TO: ANSI SCSI Committee X3T9.2
 FROM: Charles Skeldon (612) 931-8330
 Magnetic Peripherals, Inc. MTS00G
 5900 Clearwater Drive
 Minnetonka, MN 55320
 SUBJ: FLAT CABLE PROBLEMS IN DIFFERENTIAL SCSI 3/12/87

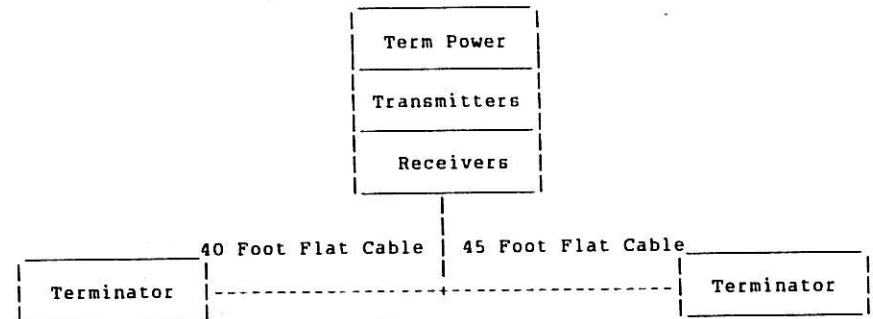
I observed that my differential SCSI got errors beyond a certain cable length. Specifically, I could not run at all with the following setup:

I found that when the target device went from Message phase to Data phase, SEL would glitch, causing the target SCSI IC (WD33C92) to drop BUSY. The problem seemed to be crosstalk between differential signals. Specifically, MSG and C/D dropped at that time. -MSG going high caused +SEL to go high, and +C/D going low caused -SEL to go low. With a long enough cable, -SEL could go higher than +SEL for a significant time, causing the receiver and the SCSI IC to see it.

Top trace:
+ MSG, C/D (TTL)
(5V/div)
 Second trace:
-SEL (differential)
(1V/div)
 Third trace:
+SEL (differential)
(1V/div). ± SEL crossed
over for about 130 ns.
 Fourth trace:
+SEL out (TTL)
(5V/div)
With 110 ns glitch.

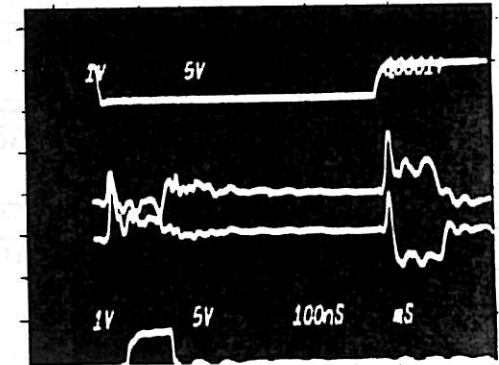
With this setup, driving MSG and C/D differentially, and leaving SEL undriven, TTL SEL received a 110 ns glitch (see photo). With cable lengths of 20 feet and 20 feet, TTL SEL had a 50 ns glitch (no photo). With cable lengths of 5 feet and 7 feet there was no TTL glitch.

Recommendation - disallow non-twisted pair cables (i.e. flat cable). The SCSI standard says, in section 4.2.2, "A 50-conductor cable or 25-signal twisted-pair cable shall be used." The term "50-conductor cable" is vague, and could include flat cable. The standard should be modified so that section 4.2.2 says, "A 25-signal twisted pair cable shall be used." Perhaps it should also specifically mention that twisted flat cable is acceptable.

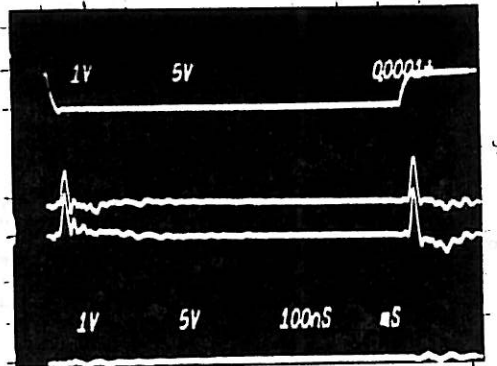
The same experiment was tried for twisted flat cable, except cable lengths were 37 feet and 27 feet. The crosstalk in that case was mostly common mode. See following photo:

In this trace, there is always at least 0.3 volts between ±SEL, insuring no glitch.
